## **FORT CONDE RESTORATION SUBDIVISION, UNIT TWO**

Engineering Comments: FINAL PLAT COMMENTS (should be addressed prior to submitting the FINAL PLAT for acceptance and signature by the City Engineer):

APPLICATION NUMBER 1 DATE August 15, 2019

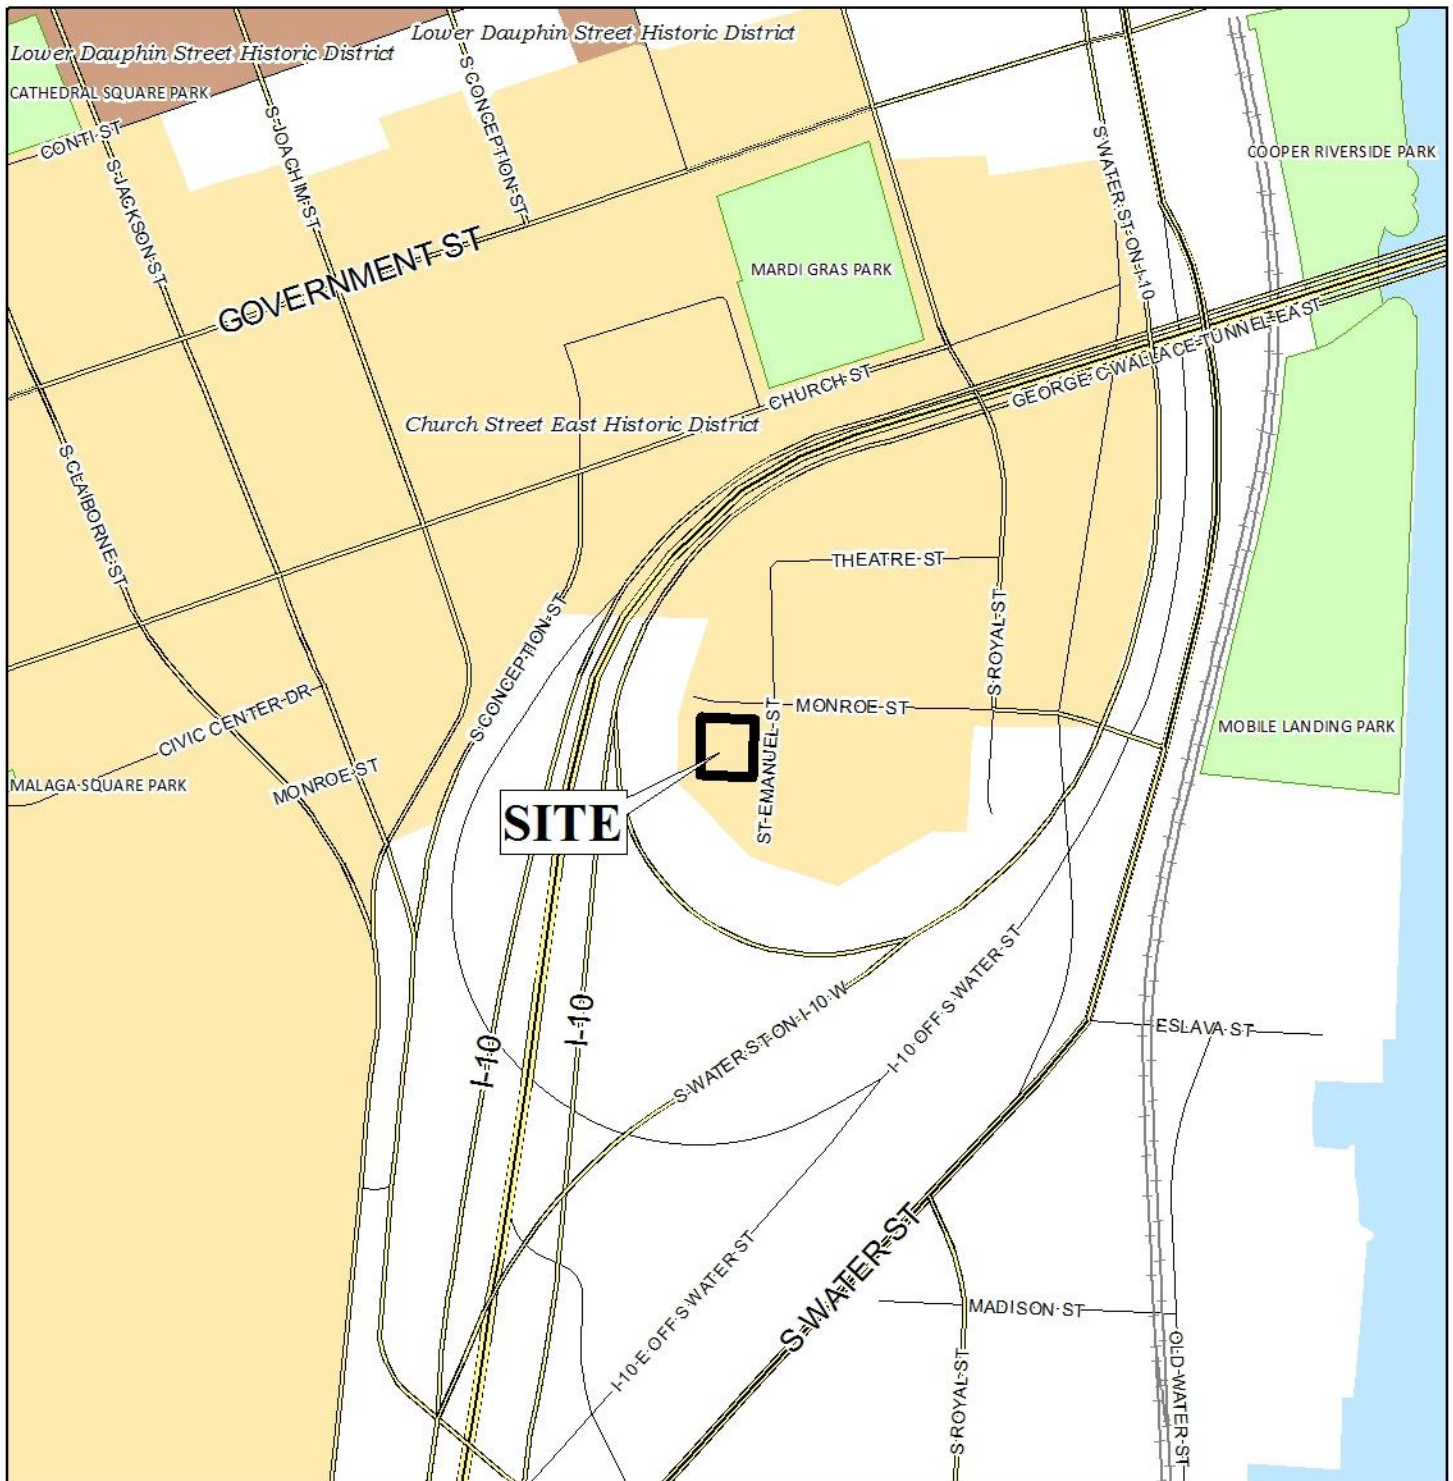
The proposed subdivision fronts Monroe Street and Saint Emanuel Street. Both are minor streets with curb and gutter. As a minor street, a 50' right-of-way width is typically required. The right-of-way width of Monroe and Saint Emanuel Street, as indicated on the preliminary plat, reflects compliance with minor street standards and if approved, should be retained on the Final Plat.

The proposed Lot 1 abuts two "B" streets, thus the applicant must indicate which street will act as the primary frontage for the lot.

Property width requirements for a T-5.1, Mixed-Use, Medium Intensity Sub-District, are a minimum of 14' and a maximum of 180' per Section 64-3.I.8.(b).3 of the Zoning Ordinance. The property width is illustrated on the preliminary plat as 55'± for proposed Lot 1 on Saint Emanuel Street and 93'± of frontage on Monroe Street. Lot 2 will have 46'± of street frontage on Saint Emanuel Street and if approved, should be retained on the Final Plat.

Per Section 64-4.I.8.(d), the DDD allows from 0' minimum to 12' maximum setback along all street frontages. The preliminary plat shows no setback requirements. If approved, the Final Plat should be amended to depict a 12' maximum building setback line along all frontages along with a note stating a 0' minimum is allowed.

The preliminary plat provides the lot sizes in square feet and acres, and if approved, this information should be retained on the Final Plat. However, the proposed lots are substandard in regards to lot size. The Preliminary Plat illustrates Lot 1 to be 5,127± square feet and Lot 2 to be 4,309± square feet, both of which are below the required minimum of 7,200 square feet for lots served by public water and sanitary sewer systems. In the DDD, it is common for lots to be less than 7,200 square feet; therefore, a waiver of Section V.D.2 of the Subdivision Regulations may be appropriate.

Per Section 64-4.I.11.(c) parking shall be accessed from the secondary frontage where available. Driveways are limited to twenty-five (25) feet in width within the frontage and a maximum of one (1) curb cut per property frontage may be permitted. Curb cuts shall meet specifications established in Chapter 57 Article IV, Driveways. As a means of access management, a note containing the Traffic Engineering Comments should be placed on the Final Plat, if approved.

With a waiver from Section V.D.2 of the Subdivision Regulations, this application is recommended for Tentative Approval, subject to the following conditions:

- 1) addition of building setbacks to reflect a maximum building setback line of 12' along all streets;
- 2) addition of a note stating that a 0' minimum building setback is allowed;

- 3) retention of the lot size information on the Final Plat to be depicted in square feet and in acres;
- 4) retention of lot widths on the Final Plat;
